### PART 1: Retrofit rev.07/02/2019 Facotec Inlet Cartridges

## PART 2: Retrofit Mylar Water Barriers to Back of Controls

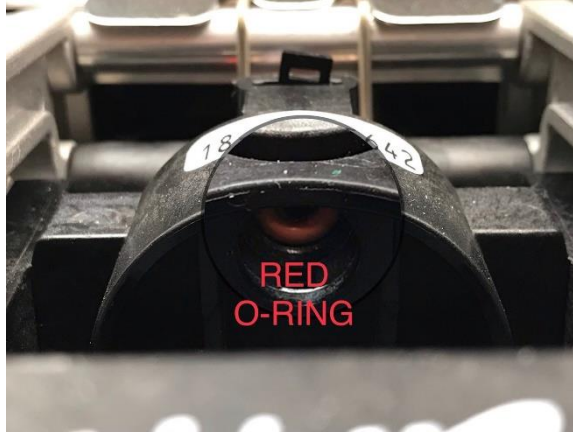
To correct problem associated with a material change made to the inlet cartridge (ref. #30-01-001-KP) in March of 2017 when new amber acetal polymer was introduced from previous revision. Trade-off of new material was that for its increased rigidity, its tensile strength was reduced, resulting in fractures occurring around the sealing edge of the component due to lack of additional reinforcement (image 1). Further revision to correct this subsequent problem has recently been made introducing a new mold with additional reinforcement around the sealing edge (images 2 and 3).

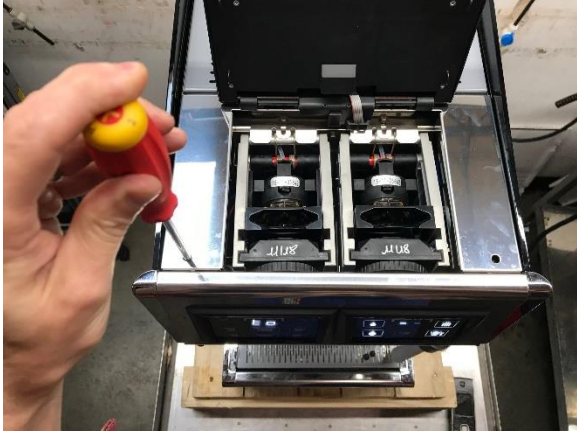
To correct problem of electronic failure associated with water/coffee jetting from vent of a compromised outlet cartridge, Mylar water barriers (ref. #45073) have been implemented shield controls.
